**Bayside Planning Panel**

Item No	5.1
Application Type	Section 96(2) Application
Application Number	DA-2015/172/02
Lodgement Date	19 August 2017
Property	2 Merchant Street, Mascot - Lot 1 in DP 851974
Owner	Mr Bobby Kendrovski
Applicant	Haidari Lashta
Proposal	Section 96(2) Application to modify Development Consent 15/172, that approved the continued use of the site as an airport valet parking facility with a new ancillary kiosk and carwash, to now construct a first floor addition to the existing administration building and to increase the number of parking spaces from 42 to 72.
No. of Submissions	One submission and one petition with (21) signatures
Cost of Development	N/A
Report by	Christopher Mackey – Team Leader Development Assessment

## Planning Assessment Report

<b>Application Number:</b>	DA-15/172/02
<b>Date of Receipt:</b>	19 August 2016
<b>Property:</b>	2 Merchant Street, Mascot Lot 1 in DP 851974
<b>Owner:</b>	Mr Bobby Kendrovski
<b>Applicant:</b>	Haidari Lashta
<b>Proposal:</b>	Section 96(2) Application to modify Development Consent 15/172, that approved the continued use of the site as an airport valet parking facility with a new ancillary kiosk and carwash, to now c

**Figure 6 – Approved Carpark layout**

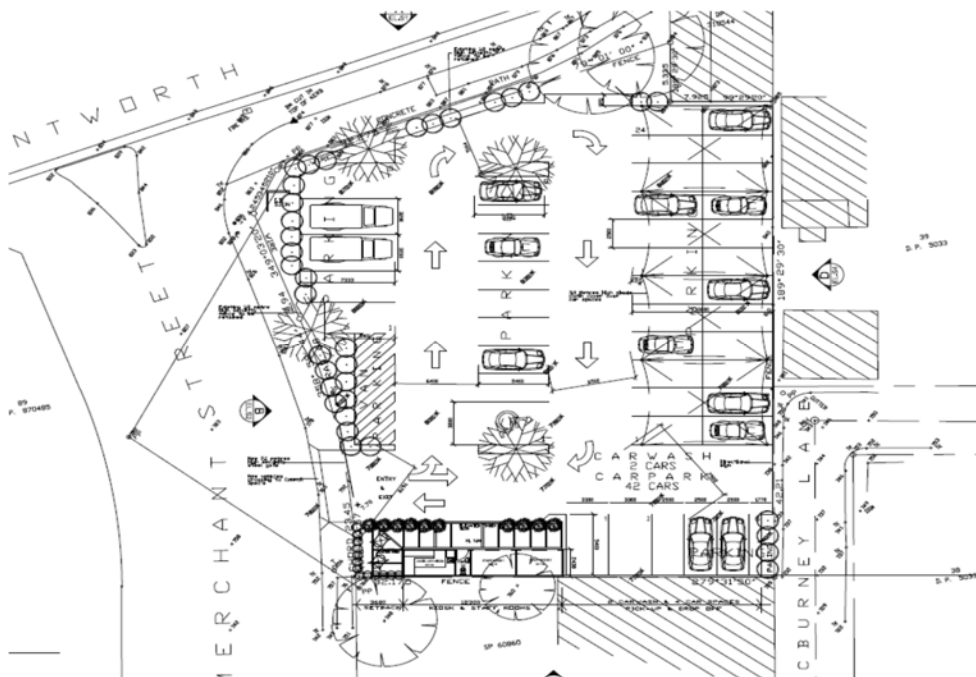
The approved car park layout is as follows:

The proposed car park arrangement under the Section 96(2) application is as follows:

**Figure 7 – Proposed Carpark layout**

Council's Traffic Engineer raised no objection with a stacked parking arrangement and increase in car spaces in principle, provided the vehicles enter and exit in a forward direction. A preference for a circulation lane at the perimeter of the site was highlighted, however shifting the aisle to the perimeter actually means that more cars need to be moved at one time as the number of stacked cars would be higher. The applicant has applied for this arrangement as it enables the mid aisle to remain free until such time as demand requires and then cars can be reversed back over the aisle to reach capacity. A condition requiring entry and exit in a forward direction has been imposed on the original consent and will remain.

SCALE: 1:100  
DATE: 28/3/2017  
DWG. NO: 1/1

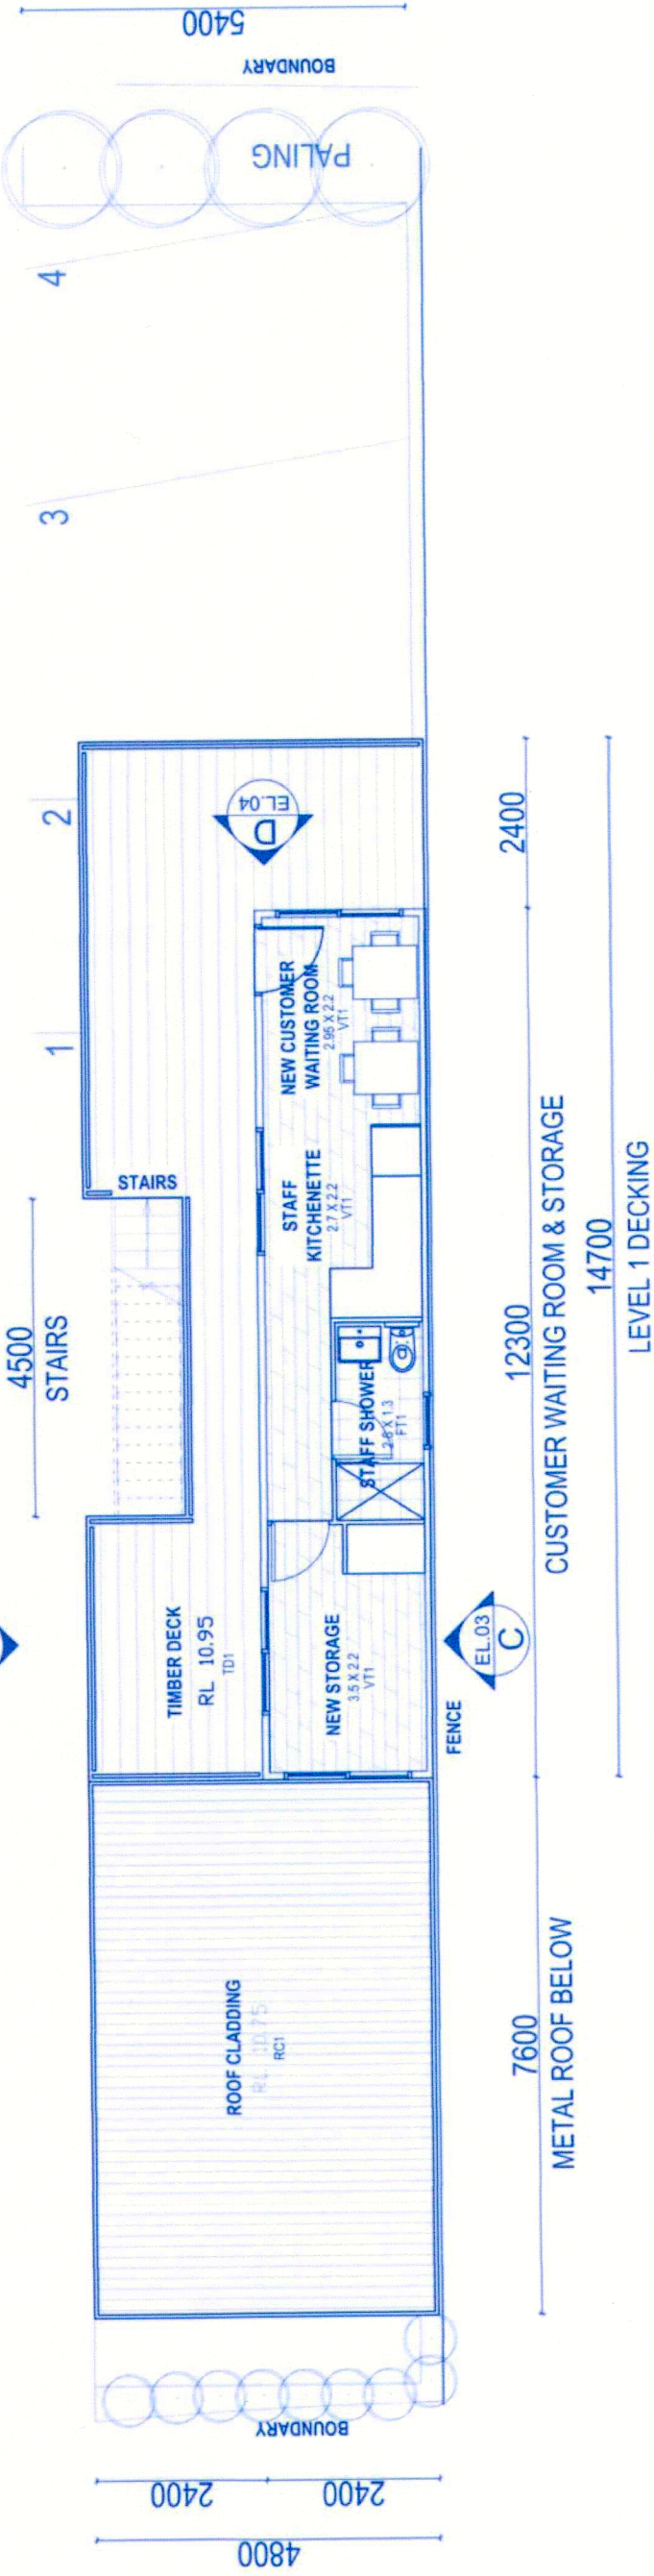
The application seeks to modify Condition 13, to increase the maximum number of cars that can be parked on site from 42 to 70. It is noted that 72 spaces are indicated on the plans, which includes 2 staff spaces as shared car wash bays and separate to the two approved shuttle spaces.

The proposed increase in the number of cars to be parked on site at any given time is a 75% increase from 42 spaces to 72 spaces. There are no physical changes to the approved parking arrangement (other than required line marking) that will be adopted during peak demand times, as an at grade stacking arrangement. There is no change to the access driveways off Merchant Street and no physical car stackers are proposed. There is an expected increase in the intensity of the use as a result of the additional traffic movements to and from the site, however the use will remain as an airport valet car parking facility and there is no change to the hours of operation or staff numbers from that already approved.
